HF-380 TRANSCEIVER (622-3580-001)
KWM-380 TRANSCEIVER (622-5093-001)
RECEIVER-EXCITER ASSEMBLY A3 (638-6908-001, -002)

SERVICE BULLETIN NO 13

AGC TIME CONSTANT CHANGES

P/O Receiver-Exciter Assembly A3
Figure 1

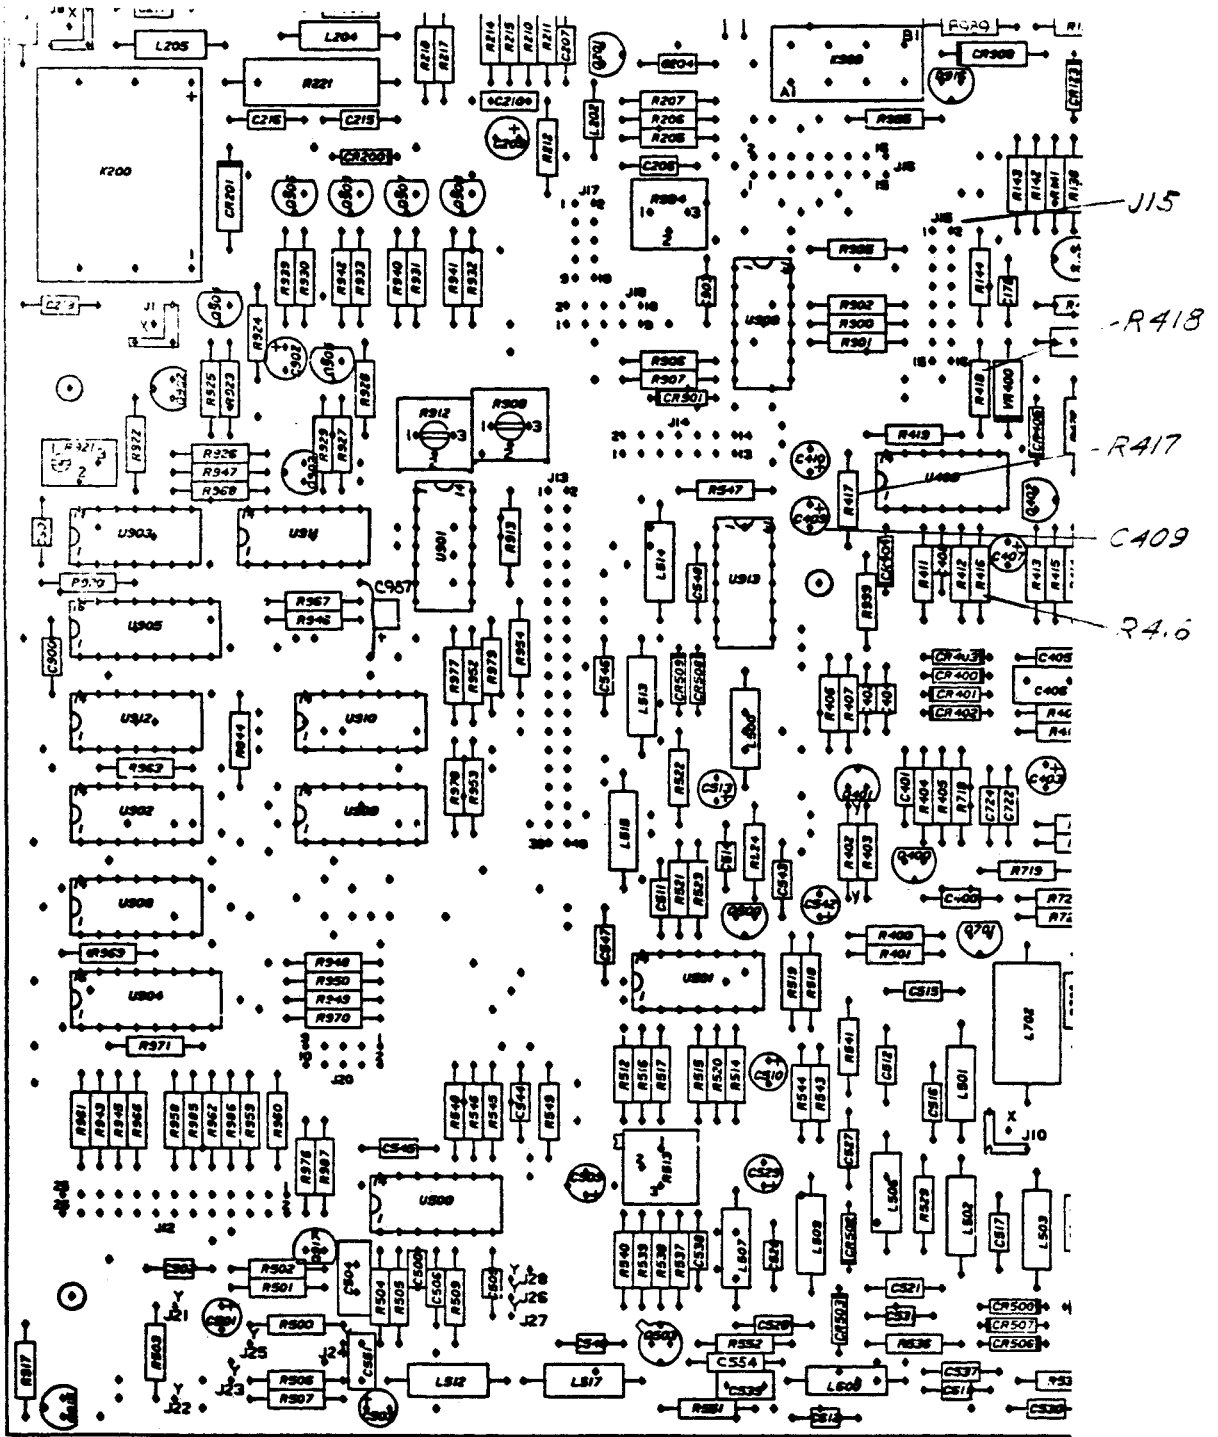
This modification improves the performance of the automatic gain control (AGC) by changing AGC time constants. The attack time is lengthened to a nominal 12 ms, the fast release time is reduced to a nominal 400 ms, and the slow release hang time is made longer but the discharge time after hang is shortened. The increased attack time improves the noise immunity of the AGC, making it less susceptible to hanging up on short noise pulses, and eliminating any AGC instability when a strong signal is on the skirt of the if crystal frequency.

This change is accomplished by changing the values of three resistors and one capacitor on receiver-exciter assembly A3.

- D. Disconnect the cable connected to J15.
- E. Remove 3.3- μ F capacitor C409 and replace it with a new 1.0 μ -F capacitor (184-9102-350).
- F. Remove 2.2-M Ω resistor R416 and replace it with a new 3.3-M Ω resistor (745-0875-000).
- G. Remove 910- Ω resistor R417 and replace it with a new 2.7-k Ω resistor (745-0764-000).
- H. Remove 27-k Ω resistor R418 and replace it with a new 2.7-k Ω resistor (745-0764-000).
- I. Reconnect the cable that was removed from J15 in step D.
- J. Reinstall the dust cover.
- K. Mark SB 13 on the service bulletin information chart. If the transceiver does not have an information chart (280-3778-010), order one and attach it near the nameplate.
